**US Army Corps  
of Engineers**  
Chicago District

# 1985 Annual Report on Lake Michigan Diversion

(Including State of Illinois Water Year 1983  
Accounting Report)

FEBRUARY 1986

Figure 2

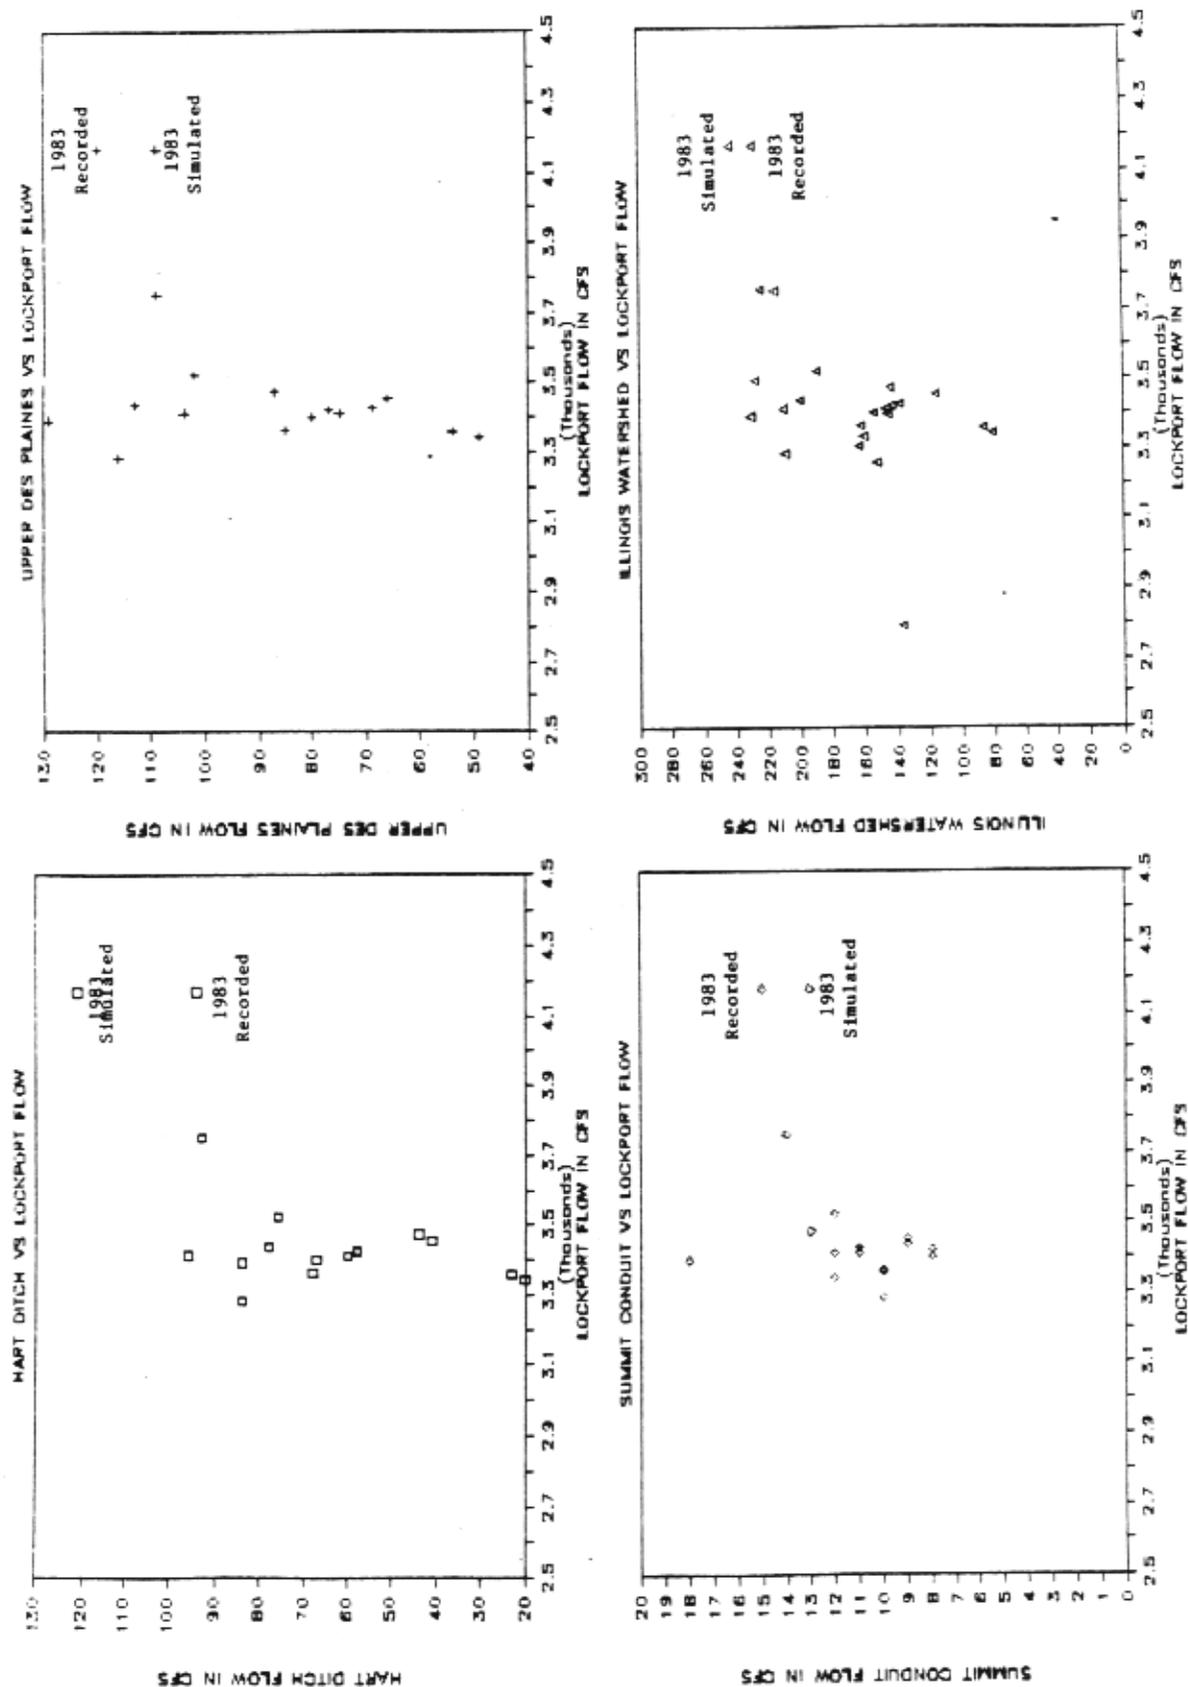
Historical flows at Lockport were plotted against historical runoff component flows (Figure 2). The plots did not result in a linear correlation between total flow at Lockport and runoff component flows. Instead, the plots showed a scattering of data points. The 1983 values for runoff components are reasonable when compared to the range of historical values, as shown in the table below.

RECORDED VS SIMULATED FLOW HYDROGRAPHS

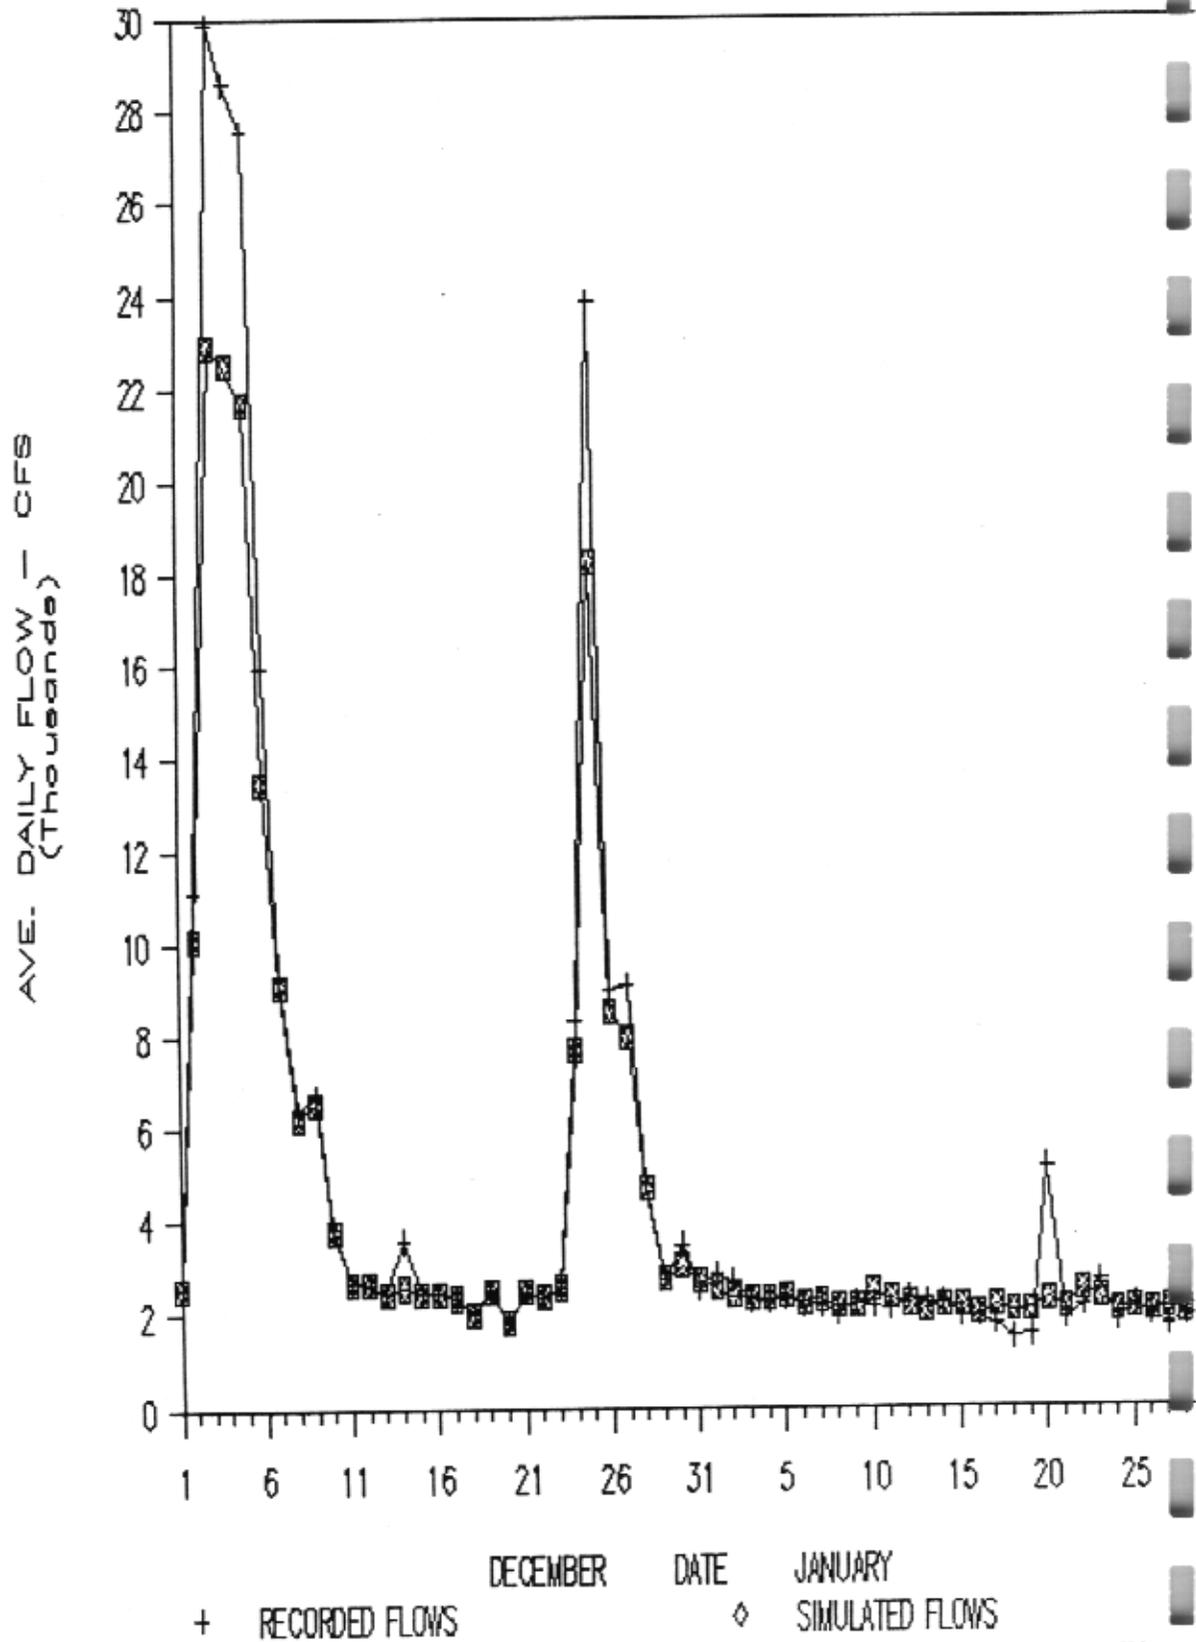
Using a form of comparative analysis of historical flows combined with samplings of flow computation checks, the Corps verified the reasonableness of the model. Simulated and reported flows for specific diversion components were compared with historic trends for the respective flow components (figure 2). The AVM data available were also used to determine the reasonableness of the hydrologic model. AVM records for 1985 were plotted with MSD Lockport records (figure 4) and the plots analyzed for trends. These trends were compared against similar plots of the hydrologic model's simulated flows vs. Lockport records for 1983 (figure 5).

In both cases, similar trends were observed. The simulated flows derived from the new accounting system tend to be higher than the Lockport record during low flow conditions. Conversely, during high flow, or storm events, the simulated flows are lower than the Lockport record. This same trend is established by the AVM for the 1985 data, indicating a strong degree of reliability in the hydrologic model. It is important to note that much of the formulation of the new hydrologic model was done prior to the availability of the AVM records; therefore, this type of a comparison is an excellent independent check.

Fig.

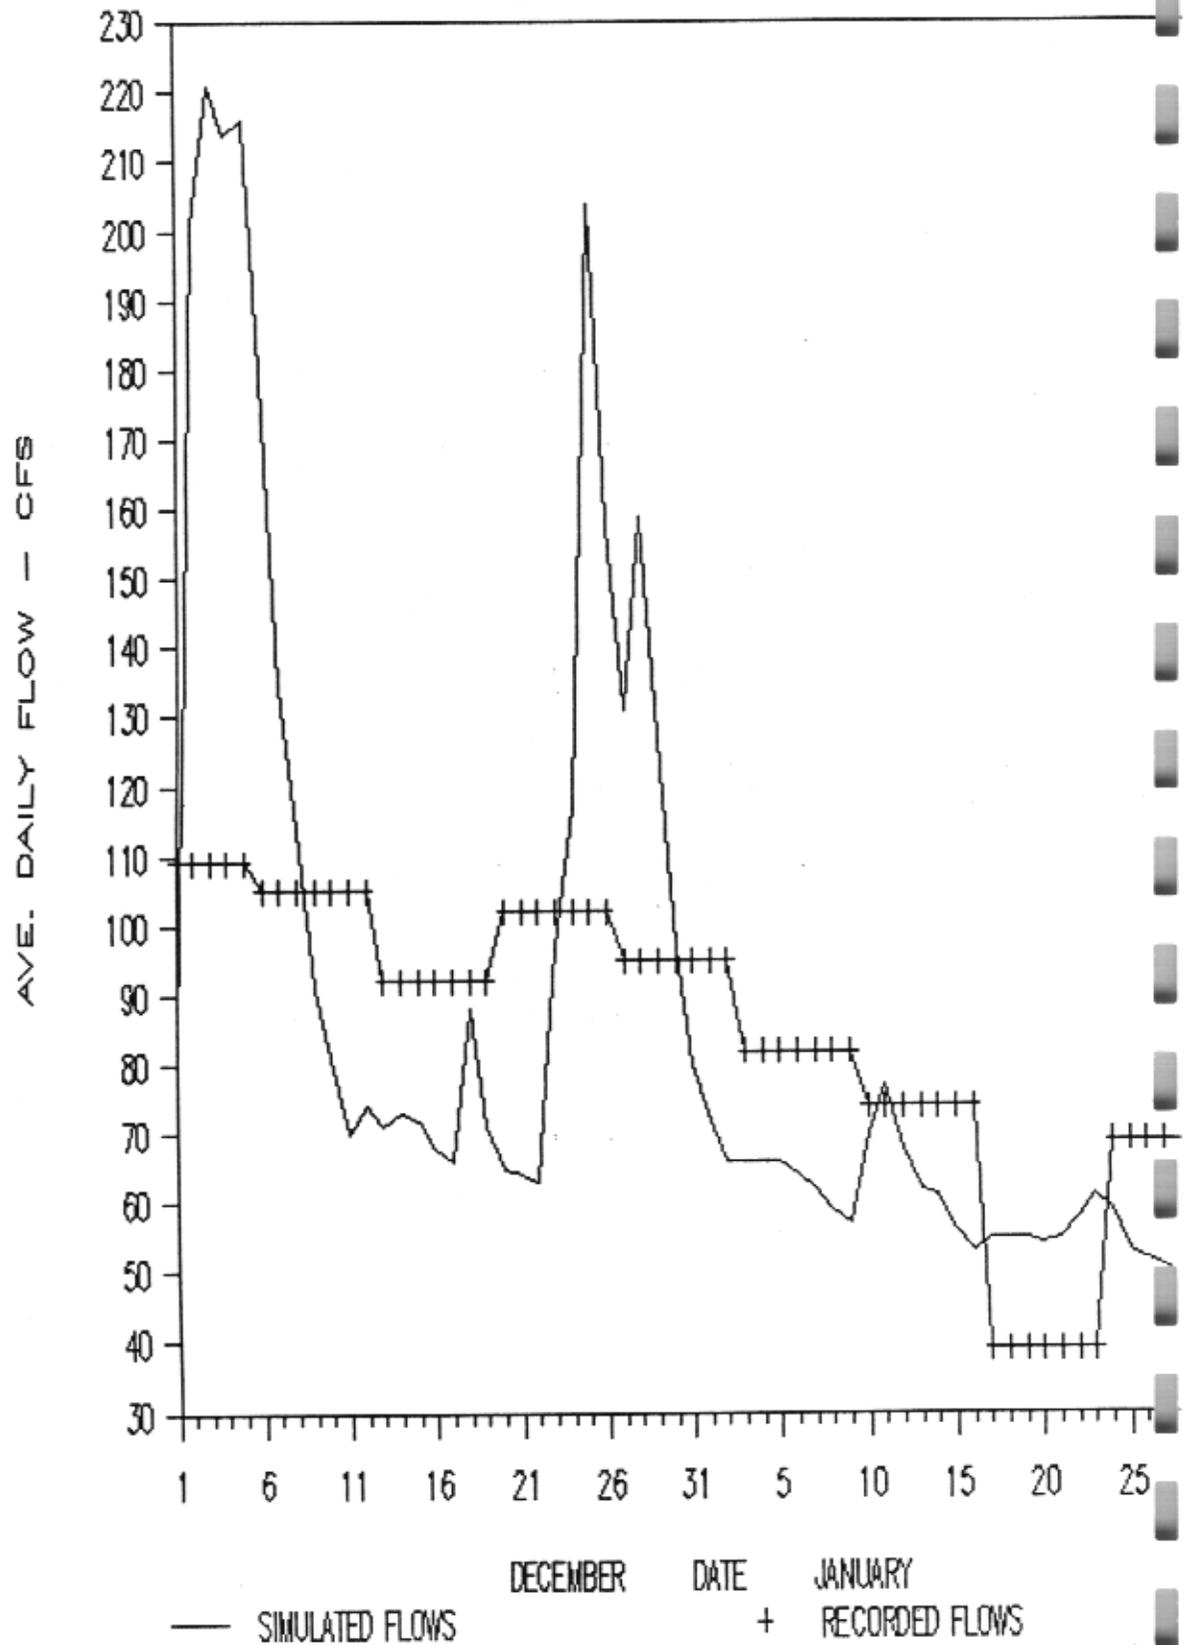
The Corps found that the simulated flows failed to match the recorded flows at the UDPPS (figure 7), but did match the flows at the West-Southwest Treatment Plant at Stickney (figure 8). A field inspection by the Corps verified that, during high flow periods, flows were capable of bypassing the UDPPS metering system. Conversely, during low or normal flows, effluent being pumped could leak back into the sump, resulting in double counting and high metered flows. During the 1983 water year, the new system reported 109 cfs of which 77 cfs flowed through the UDPPS. Direct measurements at the UDPPS were 85 cfs, or 10% higher than simulated.
